# Conceptual Review Agenda

Schedule for 03/02/15 to 03/02/15

# 404 Linden Tasting Room

**Re:** 404 Linden - Tasting Room

CONCEPTUAL REVIEW  
SITE PLAN

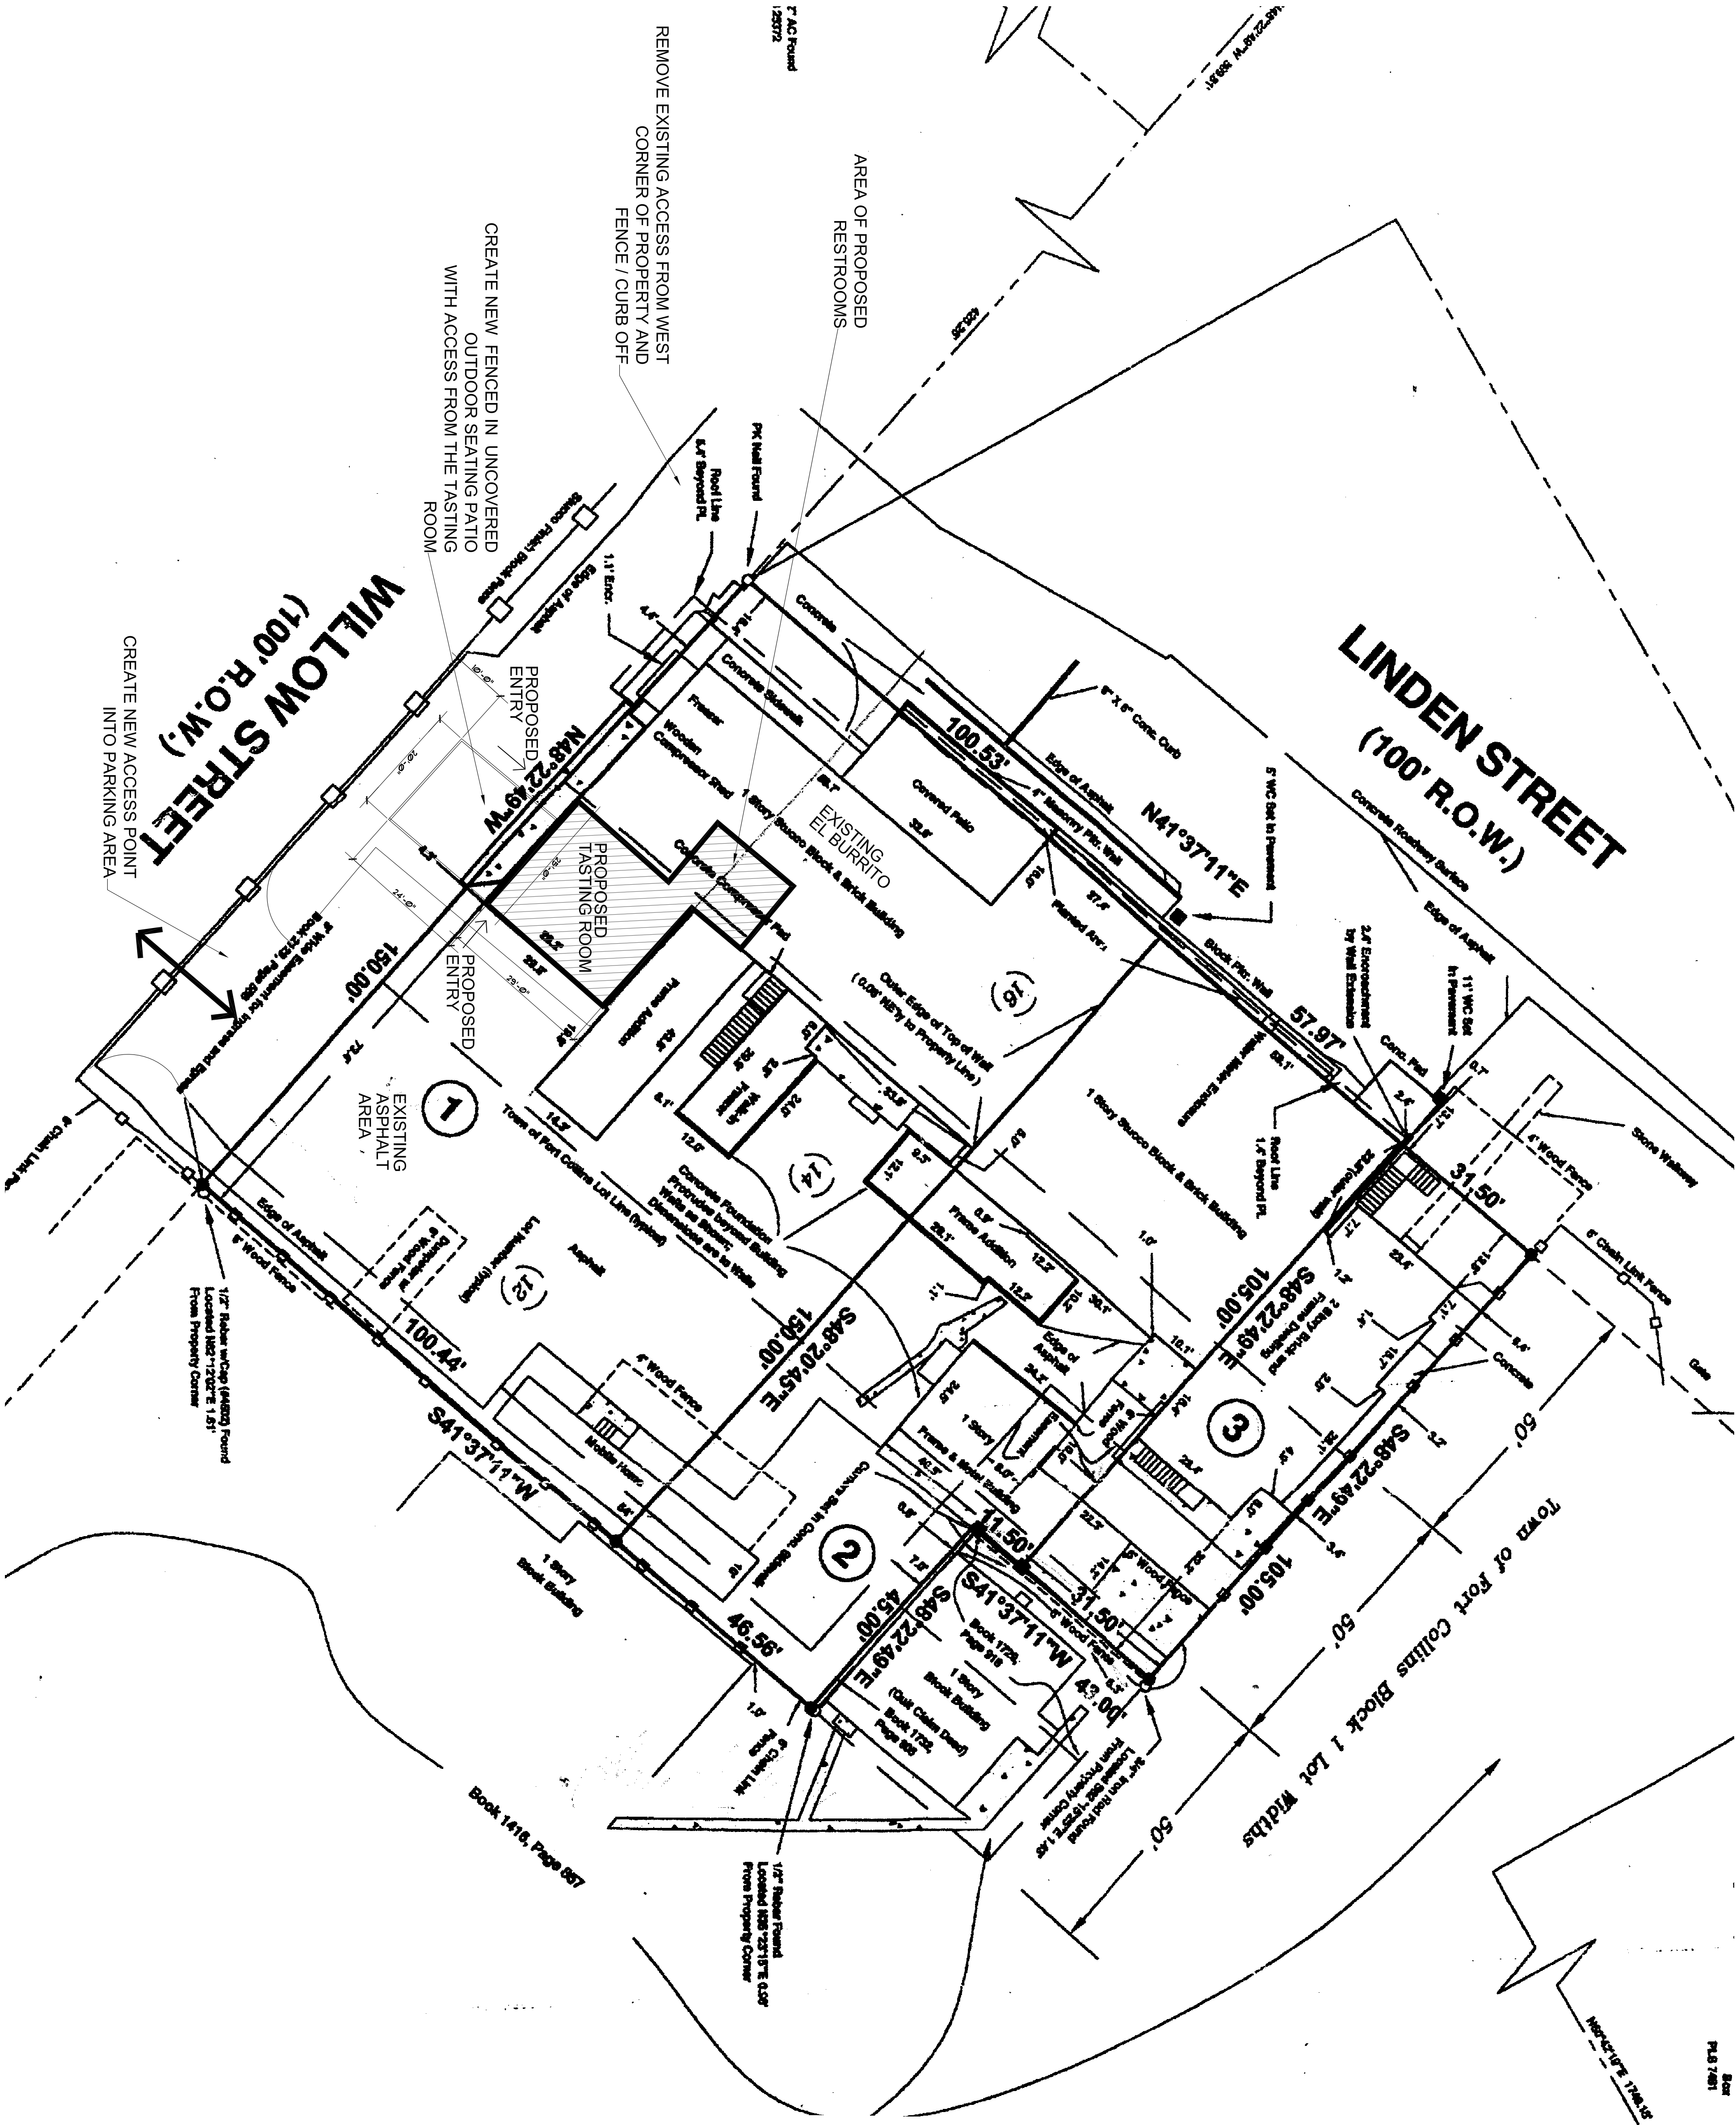
1. WHAT IMPLICATIONS WILL WE HAVE BY MOVING THE DRIVEWAY ENTRANCE? DO WE NEED TO OBTAIN APPROVAL FROM THE RAILROAD TO RELOCATE?
2. THE EXISTING SOLID WALL FENCE IS PROPOSED TO BE REPLACED WITH A NEW DECORATIVE METAL PANEL TYPE OF SCREENING. WHAT RESTRICTIONS OR ISSUES COULD BE POSSIBLE?

3. THE PROPOSED PATIO ENCROACHES OVER THE PROPERTY LINE. NO BUILDING STRUCTURES ARE PROPOSED. PATIO WILL GENERALLY CONSIST OF CONCRETE SLAB ON GRADE, A 42" HGT FENCE AS REQUIRED BY THE LIQUOR BOARD, TABLES AND UMBRELLAS. ARE THERE ANY ISSUES WITH THIS USE IN THE RIGHT-OF-WAY?

4. THE SOUTHWEST WALL OF THE PROPOSED IMPROVEMENT AREA THAT IS ADJACENT TO THE PATIO IS PROPOSED TO HAVE A ROLL-UP GLASS DOOR. THIS WALL IS LOCATED 5 FEET FROM THE PROPERTY LINE. ARE THERE ANY POTENTIAL CODE ISSUES SUCH AS FIRE RATING OR ENERGY CODE COMPLIANCE ISSUES?

1. The new curb cut will be across the tracks? That will need to be coordinated.
2. For bike and pedestrian information, Will there be a pedestrian connection out to Linden?  
And please note that bike racks will be required.
3. The anticipated change in traffic volume is not expected to rise to the threshold of needing a TIS. Based on section 4.2.3.D of LCUASS, the Traffic Impact Study requirement can be waived.

7. The outdoor seating would be permitted though an outdoor seating encroachment permit. The seating area would not be shown on the plans since the size, area, location, method and type of fencing is approved through the separate permitting process that would be done after the driveway is closed and other changes are made.

11. LCUASS parking setbacks (Figure 19-6) apply and will need to be followed if the driveway is changed and how the back parking lot is striped and parking is designed in it.
